**Subject:** [FI] S.16 Application No. A/YL-SK/371 - FI to address departemntal comments

**2<sup>nd</sup> Further Information**

**(S.16 Planning Application No. A/YL-SK/371)**

**Responses-to-Comments**

DWG. NO. PLAN 1	VER. 001
--------------------	-------------

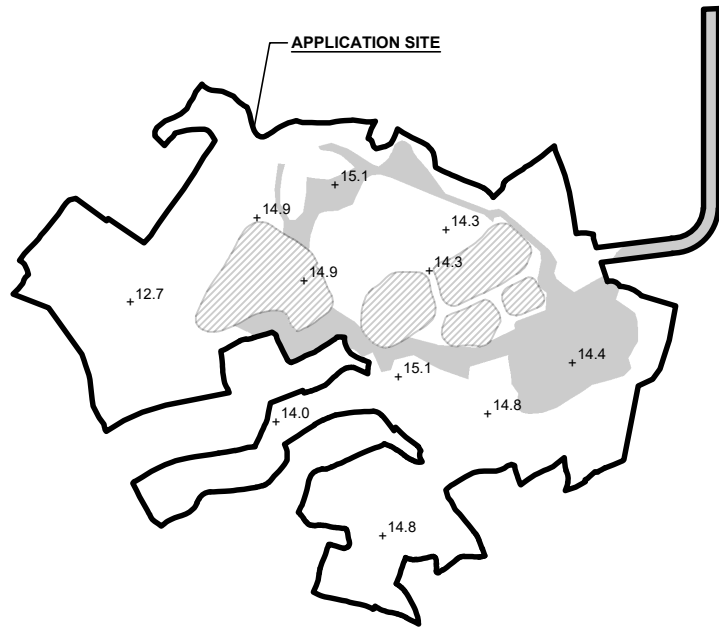
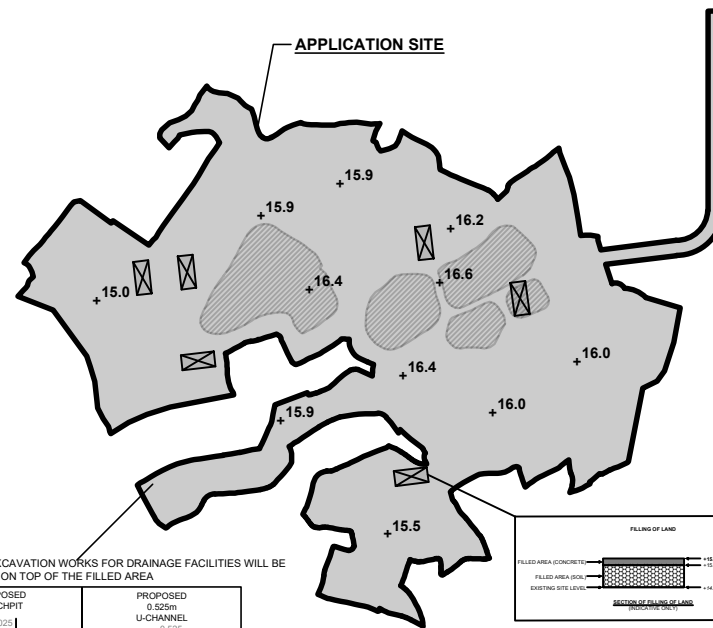
(a) The application site is situated within Shui Lau Tin Site of Archaeological Interest (SAI). After reviewing the Further Information (FI01) submitted by the applicant, the applicant is required to conduct a desktop studies to provide information of the current condition of the Subject Site (information including but not	Portions of the Site (i.e. 22,190m <sup>2</sup> ), including the dried ponds (i.e. 9,287m <sup>2</sup> ) have been filled with soil at site level ranging from +12.7mPD to +15.1mPD ( <b>Plan 1</b> ). Under the current application, the Site is proposed to be filled with soil to a depth of no more than 2.3m for open storage area and circulation space, with approximately 1,320m <sup>2</sup> of the Site is proposed to be filled with no more than 0.2m of concrete at the top of the filled area to facilitate a flat surface for site formation of structures.

<p>limited to the area that had been filled up, the thickness of the modern fill and area that had been disturbed) and details of the works, the disturbance to be caused by the proposed application to the archaeological deposits, the impact assessment on the archaeological potential of the Subject Site and so on in agreement with AMO. According to the result of the baseline review, if an archaeological investigation is necessary, the applicant shall engage an archaeologist to apply for a licence under the Antiquities and Monuments Ordinance, Cap. 53 to conduct it. An archaeological impact assessment (AIA) shall be submitted to AMO for agreement prior to applying for the licence. Subject to the findings of AIA, appropriate mitigation measures, if needed, shall be recommended for agreement by AMO and implemented by the Applicant to the satisfaction of AMO.</p>	<p>Regarding the drainage facilities, including peripheral u-channels and catchpits proposed in the revised DIA report, excavation work for the proposed drainage facilities (i.e. Approximately 478m<sup>2</sup> of the Site will be excavated of not more than 1m in depth for drainage facilities) will be carried out on top of the filled area upon the DIA is considered acceptable by the Drainage Services Department. As the small scale of excavation work is intended to facilitate the required drainage facilities and <u>no</u> excavation work would be conducted on the existing ground, adverse impact of Shui Lau Tin Site of Archaeological Interest should <u>not</u> be anticipated. Please refer to the photomontage and revised DIA at <b>Annexes III and VI</b> for details.</p>

DWG NO. PLAN 3	VER. 002
-------------------	-------------

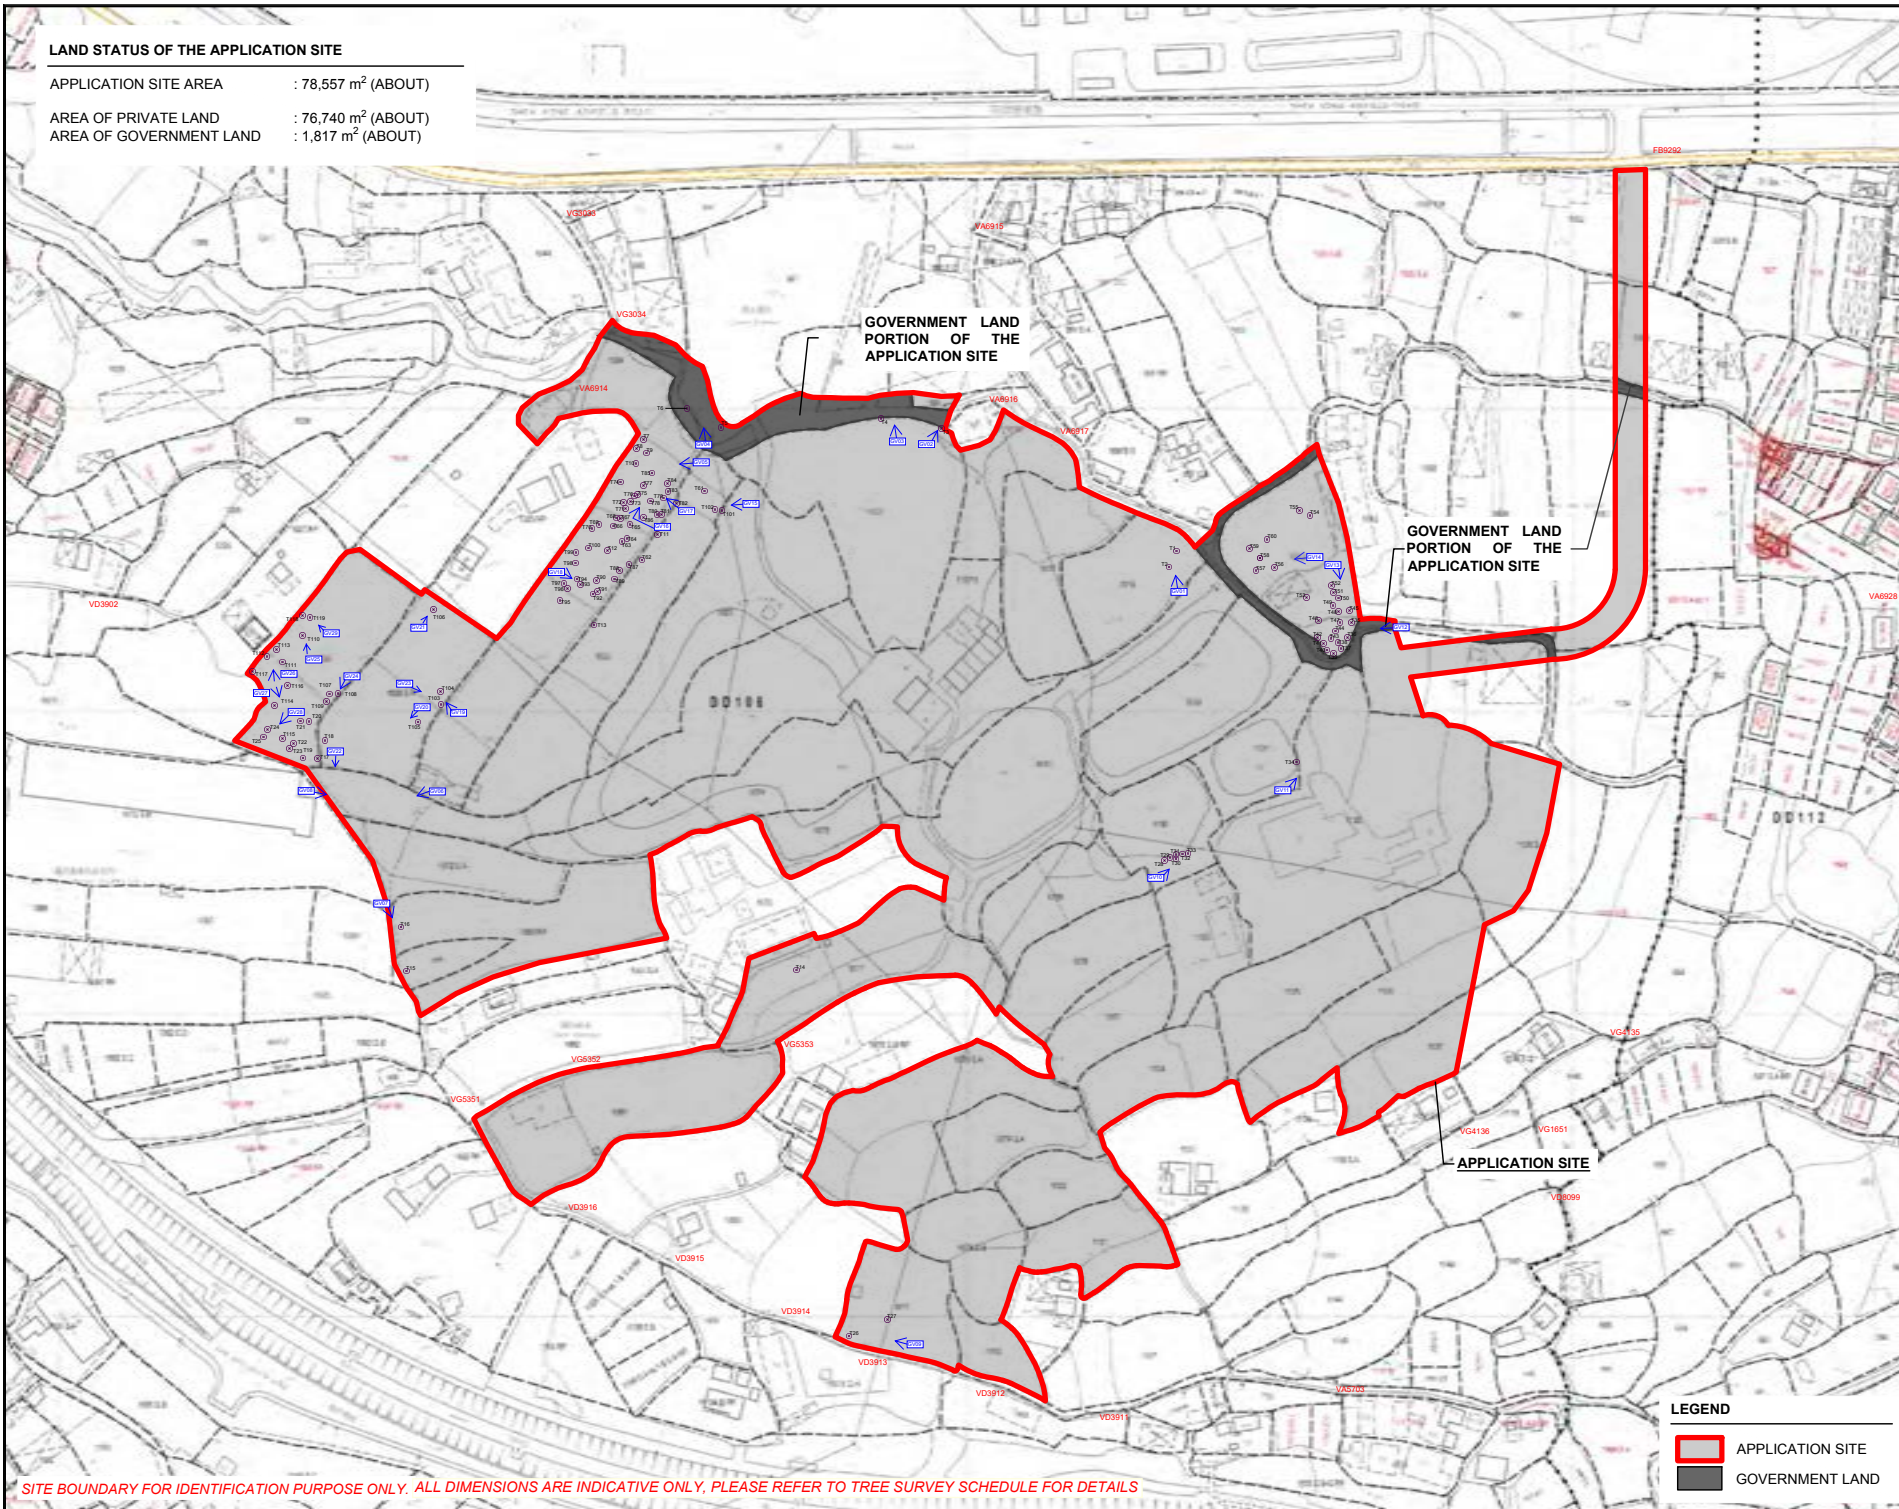
(b)	Based on our site photos taken in May 2024, approximate 3 nos. of <i>Aquilaria sinensis</i> (土沉香) and which is rare and protected species were observed in the west of the site near the annotation "GV05" in Tree Survey Plan (Plan3). The applicant is advised to review the Tree Survey Plan and avoid removal of rare and protected species.	T61, T101 and T102 were newly records as <i>Aquilaria sinensis</i> 土沉香(牙香樹) at the Site near "GV05". These trees will be preserved and maintained by the applicant during the planning approval period.
